PCD FILE NO. PPR-21-033

PLANNING NOTE: This review is for the Variance of Use request. Additional comments will be made during implementation of a Site Development Plan, which follows the Variance request.

GATEWAY TRUCKING SITE DEVELOPMENT PLAN	
SITE DEVELOPMENT PLAN	
SHEET	1 OF 2
JOB NO.	25215.00

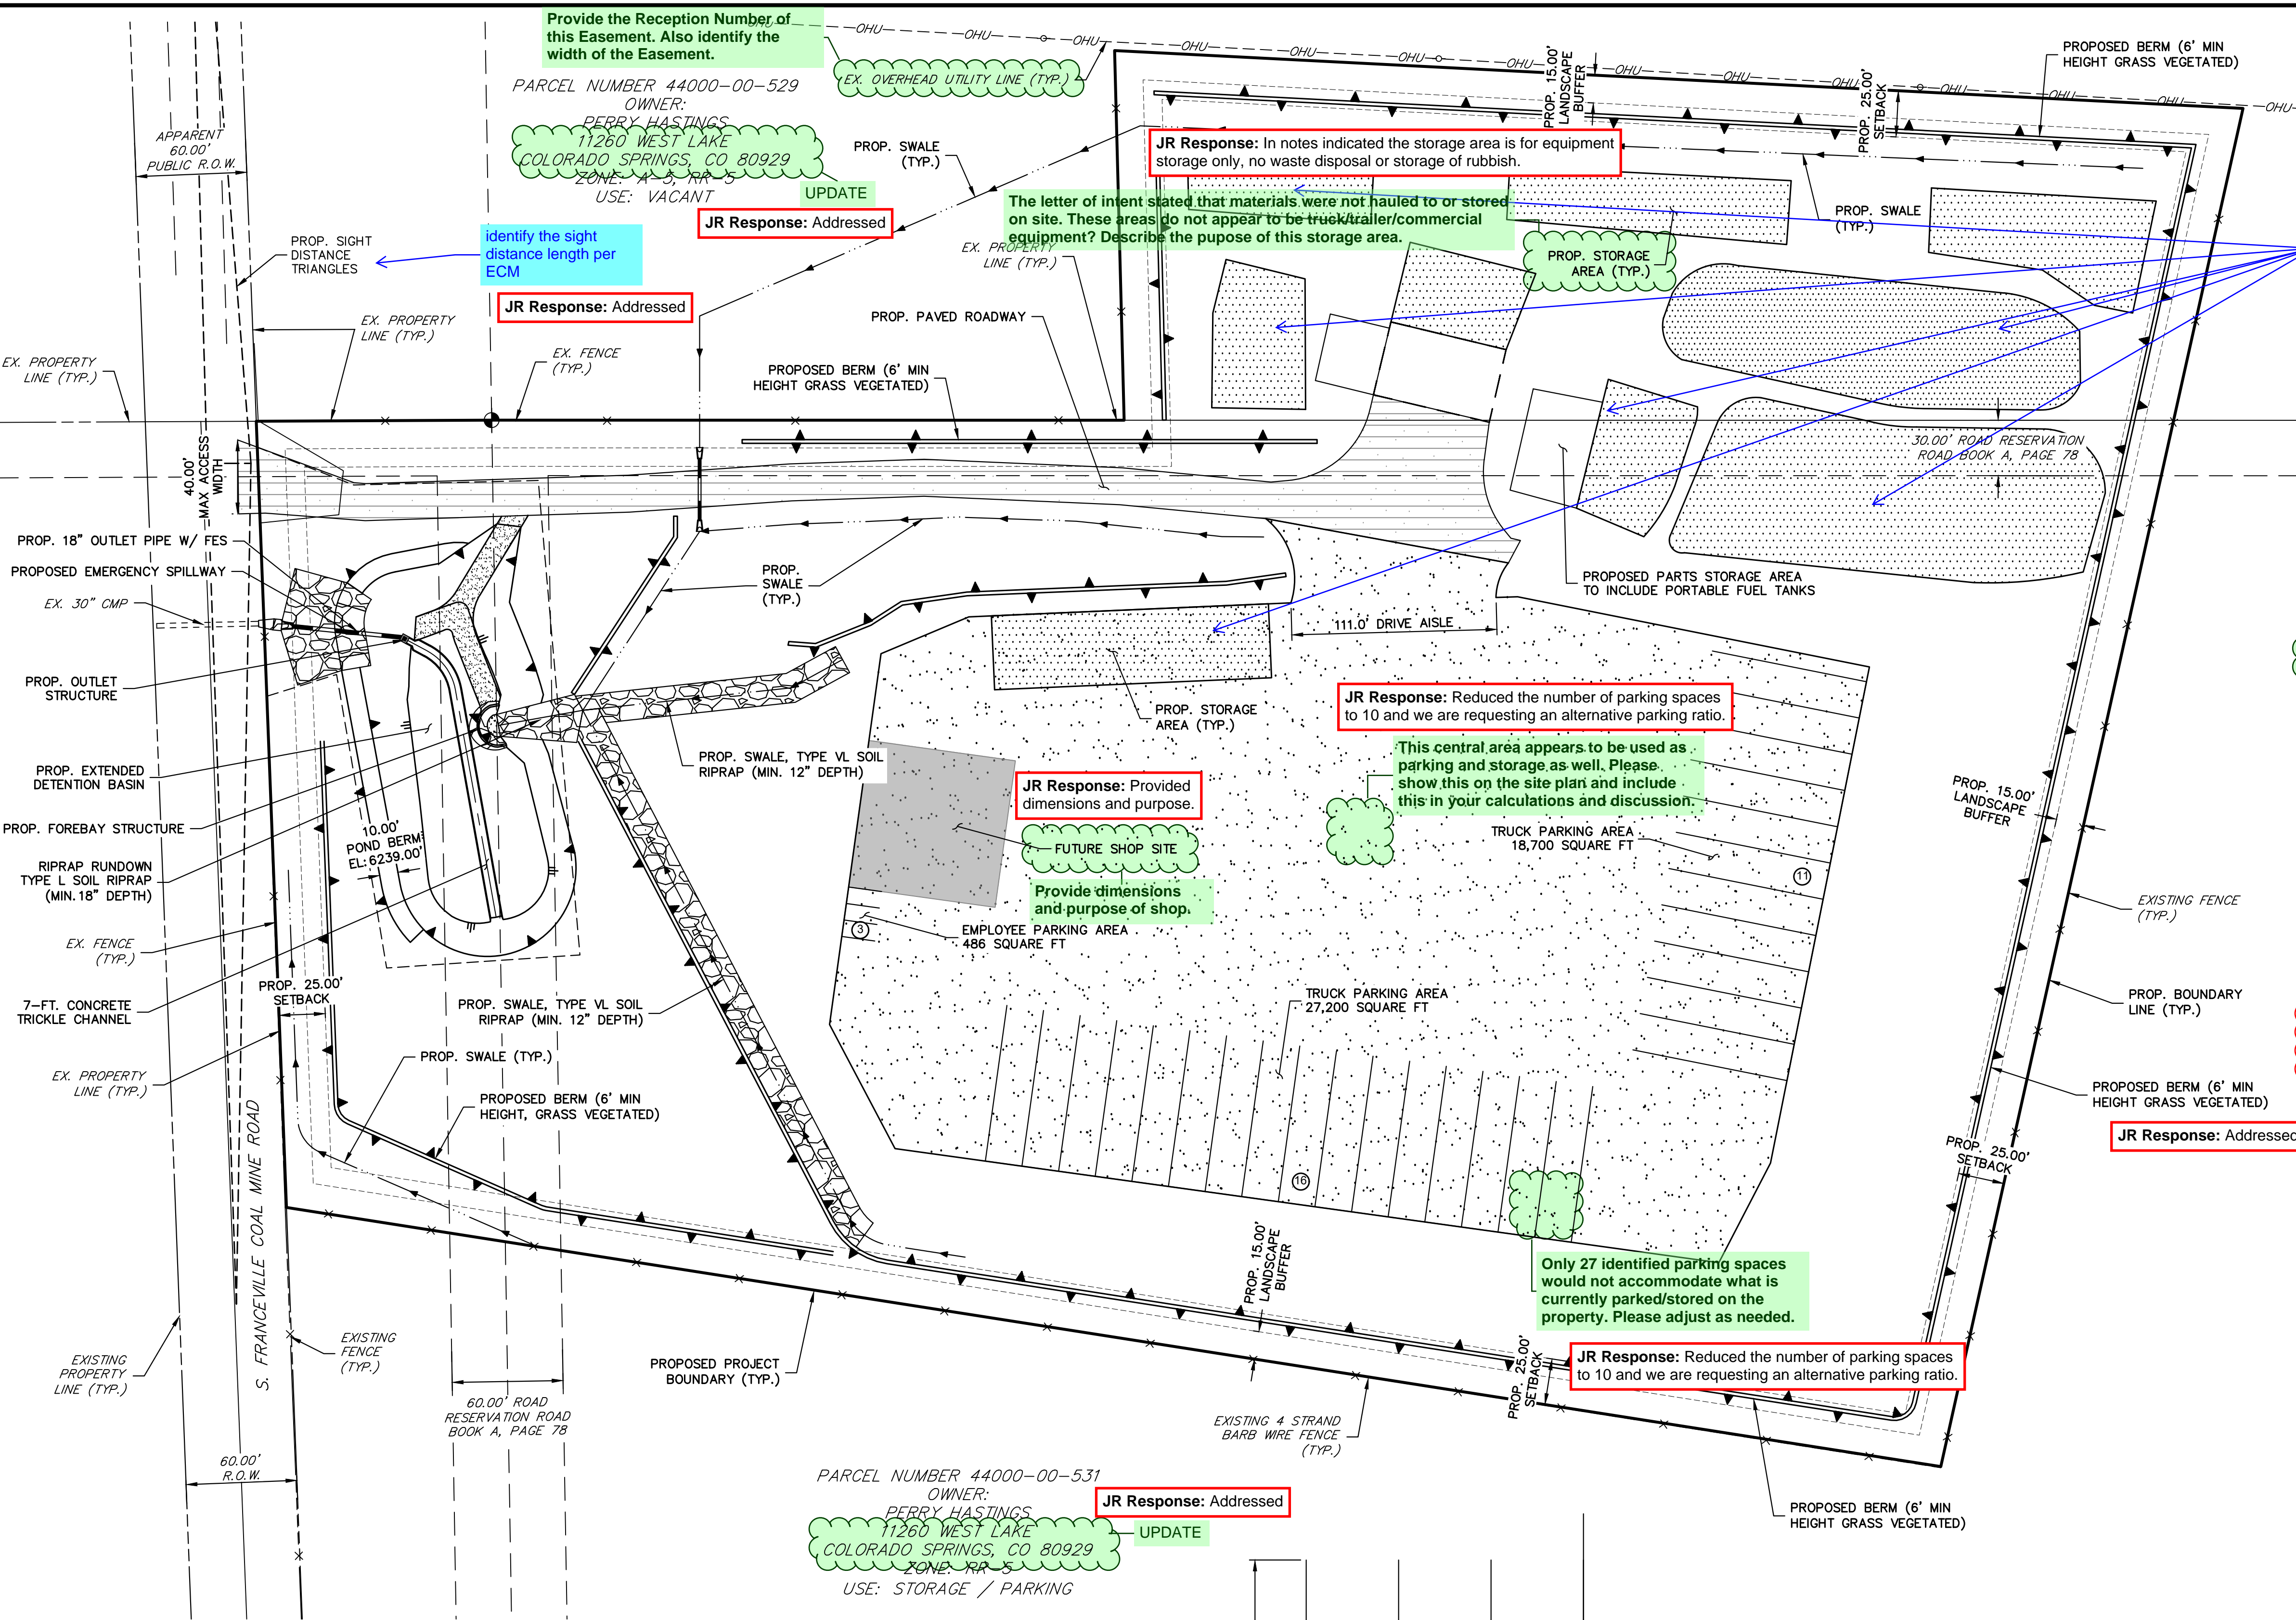
Provide the Reception Number of this Easement. Also identify the width of the Easement.

The letter of intent stated that materials were not hauled to or stored on site. These areas do not appear to be truck/trailer/commercial equipment? Describe the purpose of this storage area.

Add soft of these storage areas

Identify the sight distance length per ECM

This central area appears to be used as parking and storage as well. Please show this on the site plan and include this in your calculations and discussion.

FUTURE SHOP SITE
Provide dimensions and purpose of shop.

Only 27 identified parking spaces would not accommodate what is currently parked/stored on the property. Please adjust as needed.

DEVELOPMENT TIME TABLE:
SUMMER 2025
Commercial vehicle storage, most like Code's "Contractor's Equipment Yard". ALSO, address the proposed building. The previous site plan showed 30 employee parking spaces. Is that no longer needed?

8.00' (TYP.)
Minimum width is 9.00'
JR Response: Addressed

JR Response: Still working on tracking down this information.

JR Response: In notes indicated the storage area is for equipment storage only, no waste disposal or storage of rubbish.

JR Response: Addressed.

JR Response: Addressed

JR Response: Reduced the number of parking spaces to 10 and we are requesting an alternative parking ratio.

JR Response: Provided dimensions and purpose.

JR Response: Addressed

JR Response: Reduced the number of parking spaces to 10 and we are requesting an alternative parking ratio.

SITE PLAN

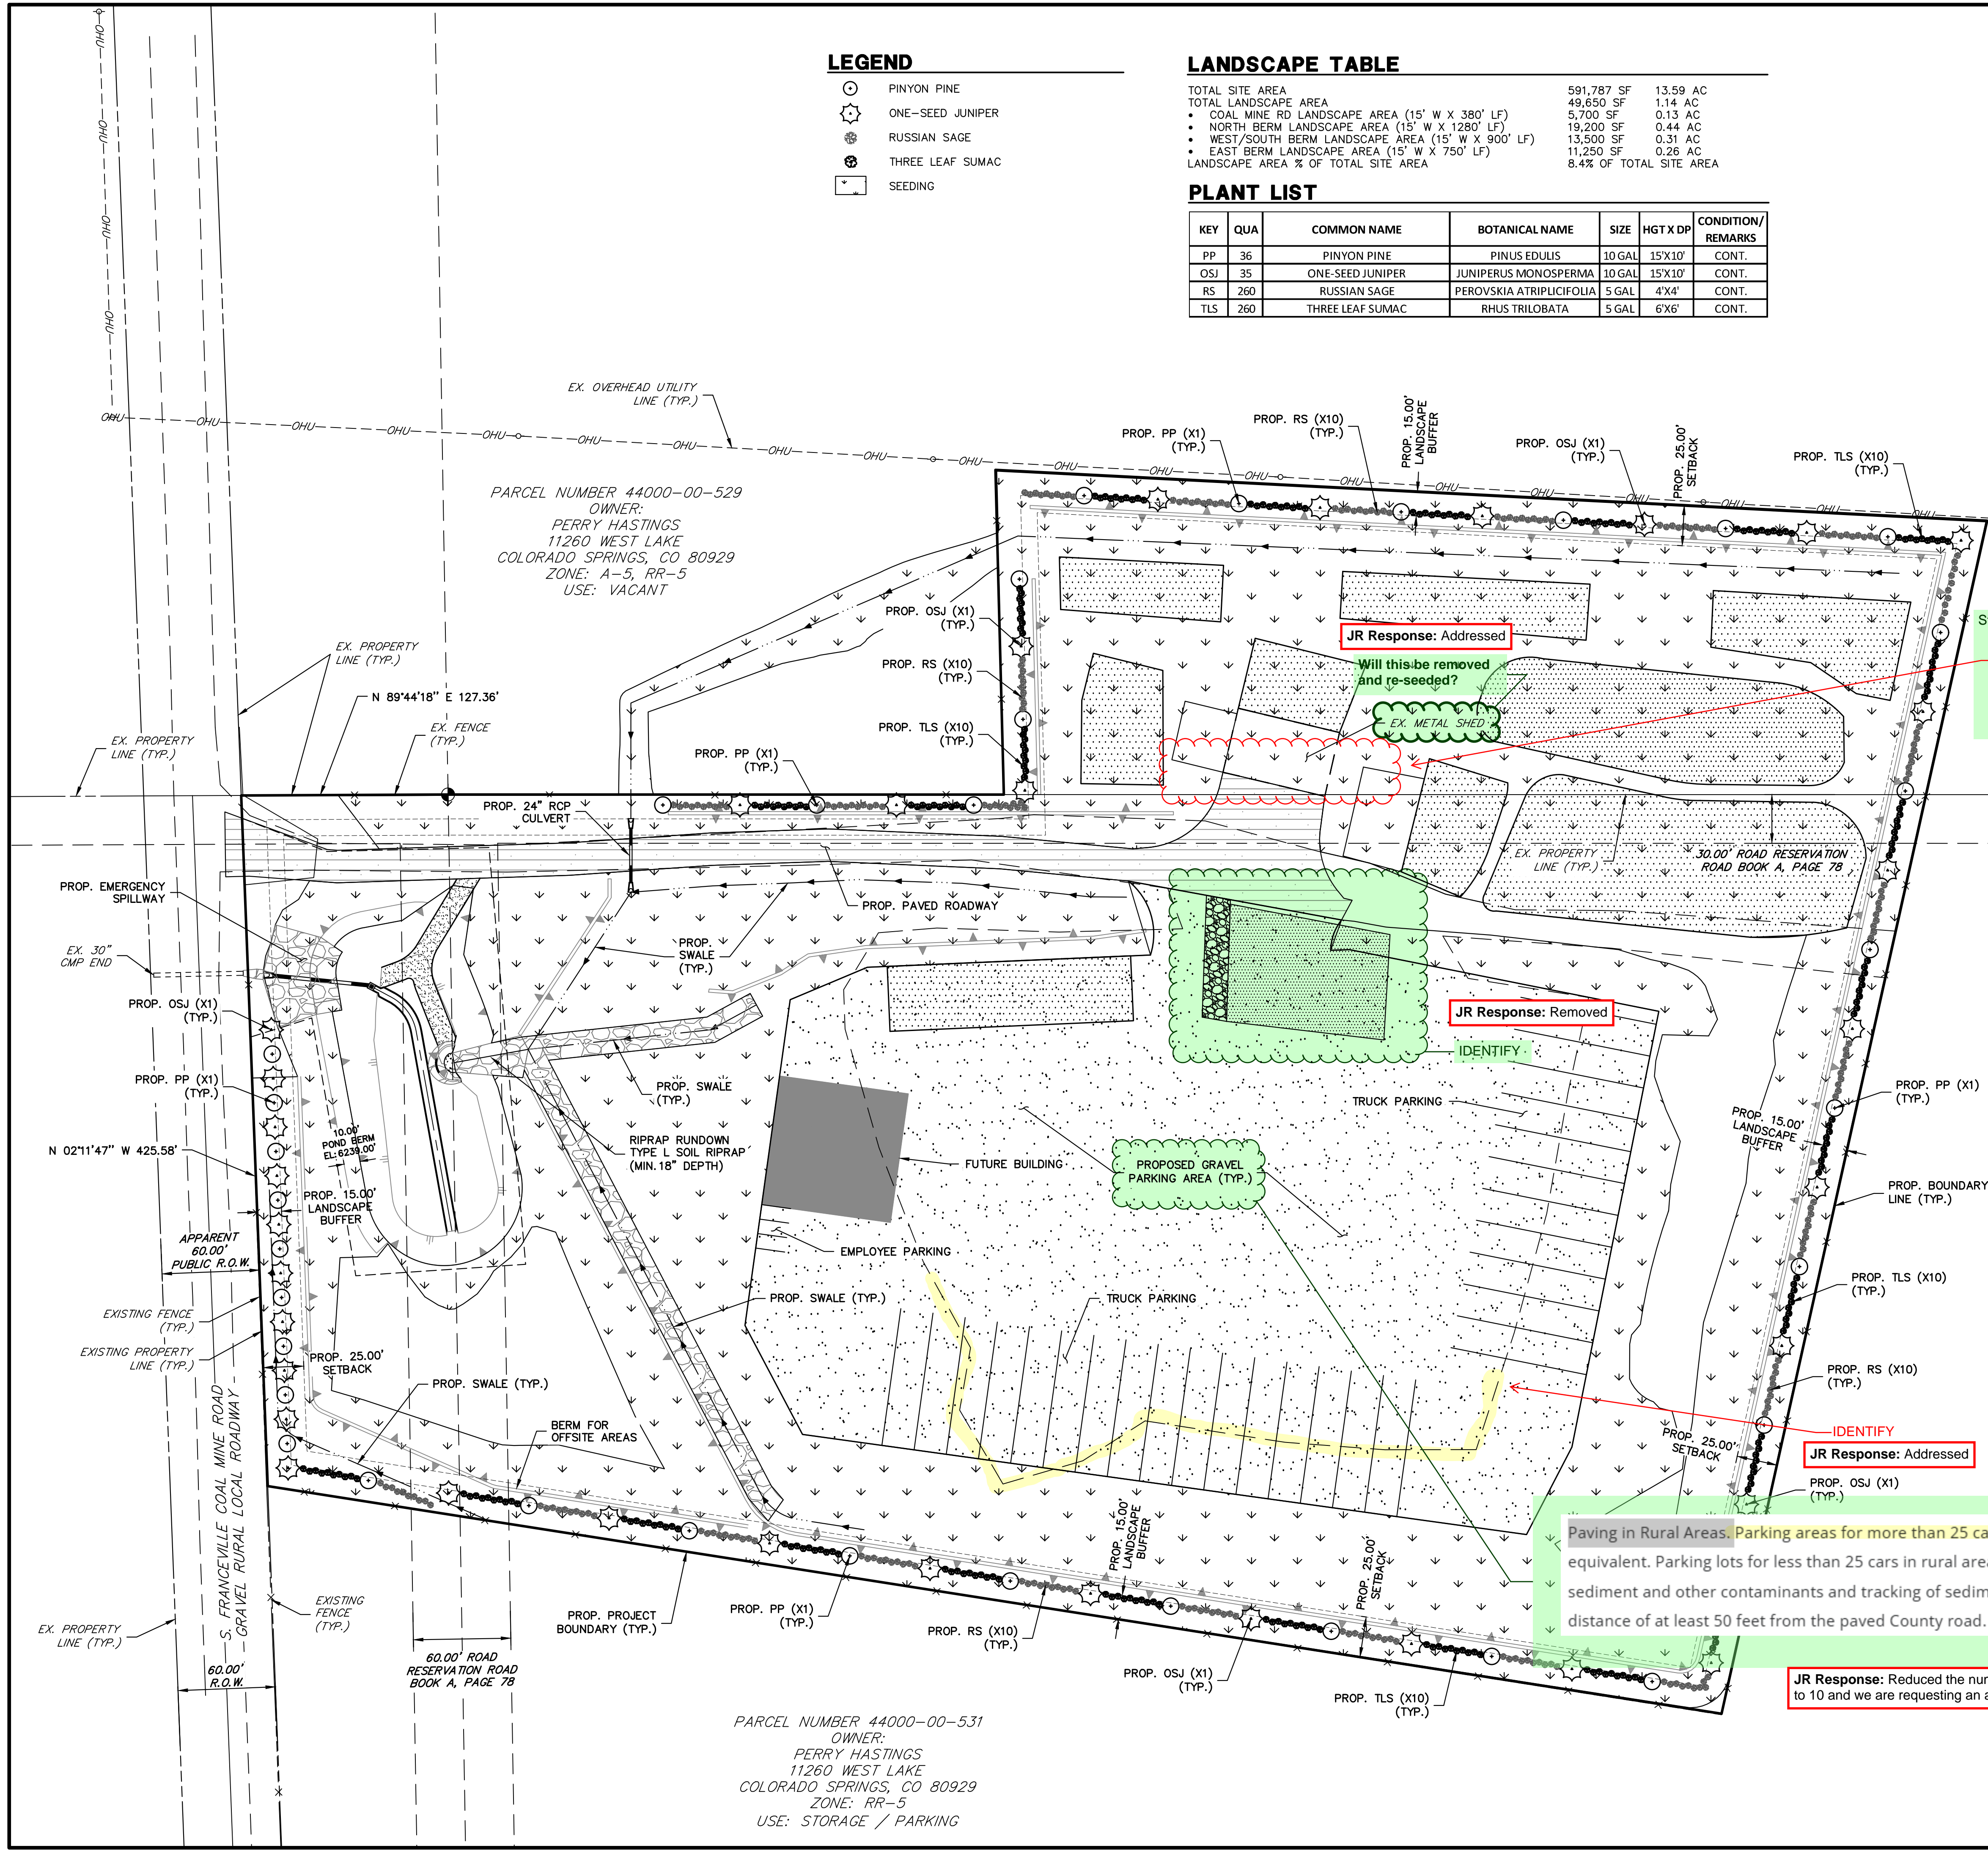
Structures may not encroach into the setbacks.

Paving in Rural Areas. Parking areas for more than 25 cars in rural areas shall be paved with asphalt, concrete, Modular Porous Block Pavement or the equivalent. Parking lots for less than 25 cars in rural areas may use rock or gravel or other measures instead of pavement to prevent erosion or runoff of sediment and other contaminants and tracking of sediment onto paved roadways. Any access to a paved County-maintained road shall be paved for a distance of at least 50 feet from the paved County road.

JR Response: Using the guidance from EPC, we will be pursuing a site boundary change.

JR Response: Reduced the number of parking spaces to 10 and we are requesting an alternative parking ratio.
